World Forum for Harmonization of Vehicle Regulations**Working Party on Passive Safety****Fifty-sixth session**

Geneva, 9-12 December 2014

Regulation No. 94 (Frontal collision)**Proposal for 03 series of amendments to Regulation No. 94
(Frontal collision)****Submitted by the expert from France as Chair of the Informal Working
Group on Frontal Impact***

Figure 1

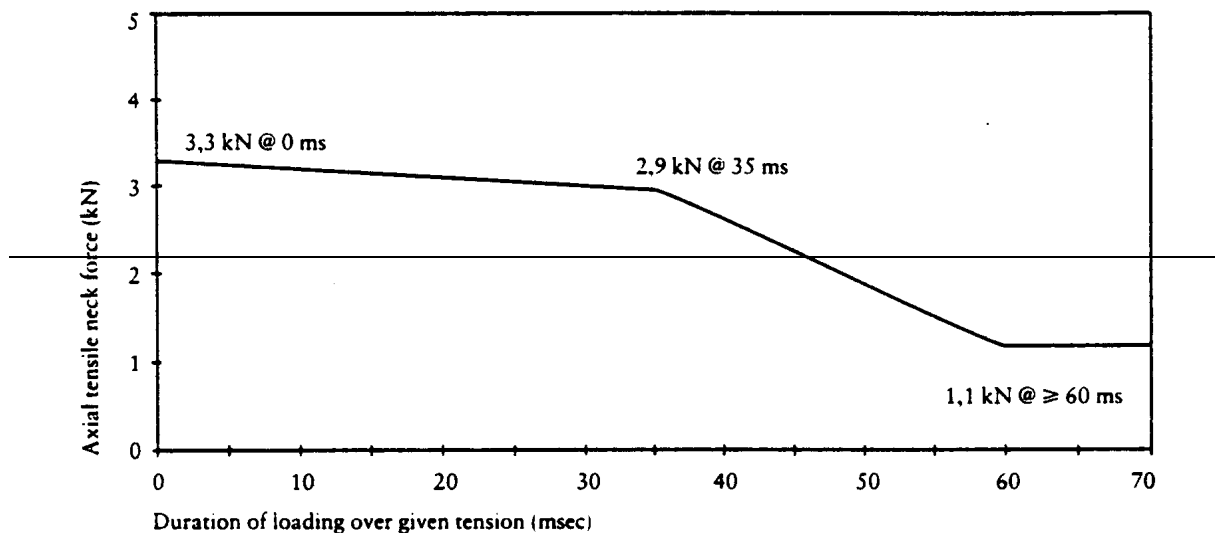
"5.2.1.2. The ~~Neck Injury Criteria for neck (NIC)~~ shall not exceed the ~~values shown in Figures 1 and 2;~~¹ **following values:**

- (a) **The axial tensile neck force shall not exceed 3.3 kN;**
- (b) **The fore/aft shear forces at the head/neck interface shall not exceed 3.1 kN;**
- (c) **The neck bending moment about the y axis shall not exceed 57 Nm in extension.**
